Dealer Service Instructions for:

Safety Recall M36 / NHTSA 12V-560 Seating Capacity Label

2013 (WD) Dodge Durango

Figure 1 – Driver’s Side “B” Pillar Shown

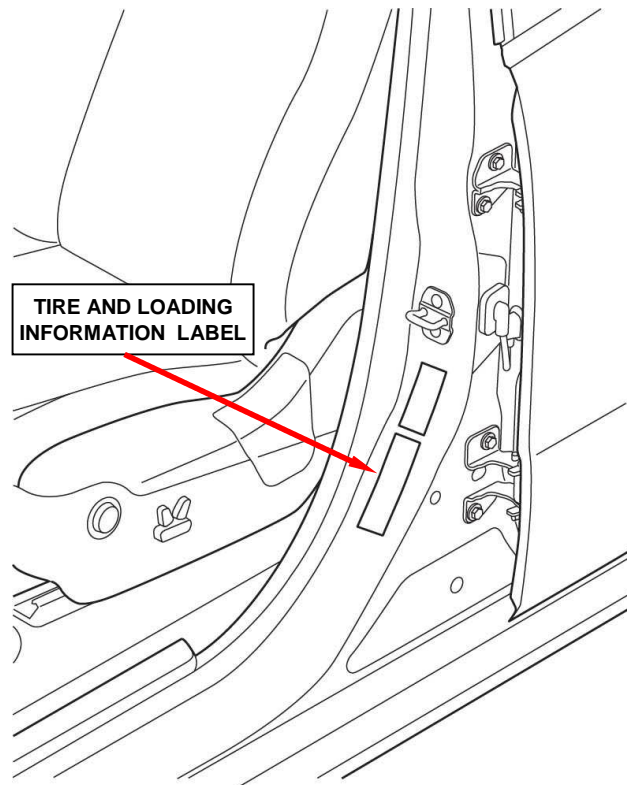
1. Open the driver’s door and locate the Tire and Loading Information label on the driver’s side “B” pillar as shown in Figure 1.
2. Clean the existing Tire and Loading Information label with alcohol / glass cleaner or equivalent and a soft cloth to remove any dirt, oil residue or grease.
3. Remove the overlay label from its paper backing and carefully install it over the seating section of the Tire and Loading Information label (Figure 2). Firmly press and smooth the overlay label to the surface of the existing Tire and Loading Information label to ensure good adhesion.

Figure 2 - Tire and Loading Information Label with Overlay

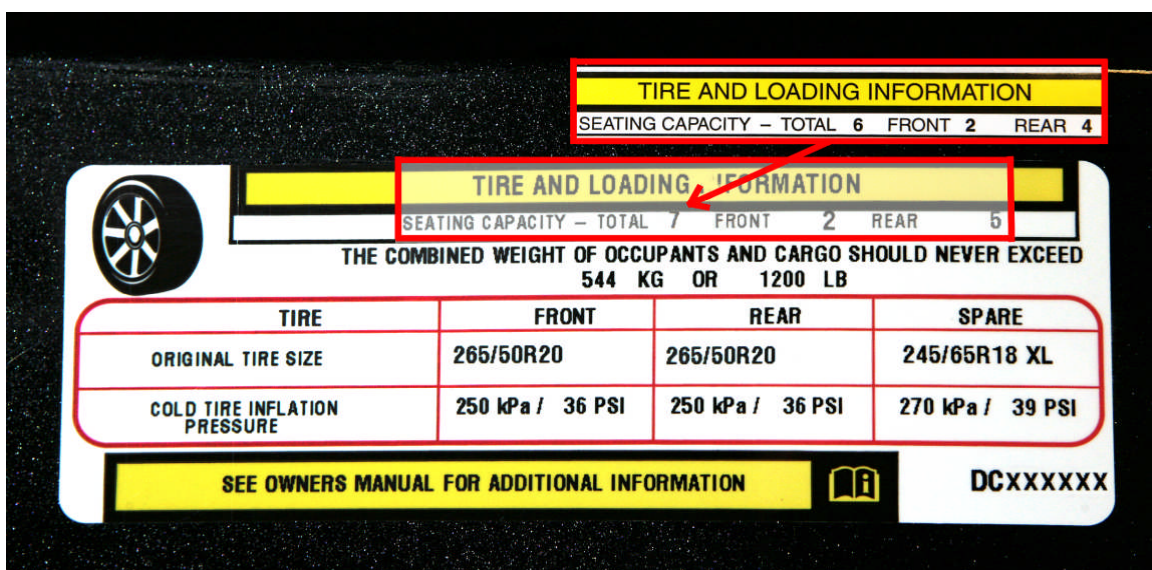
Dealers are required to apply an Overlay label to the Tire and Loading Information label on all involved vehicles in new vehicle inventory.
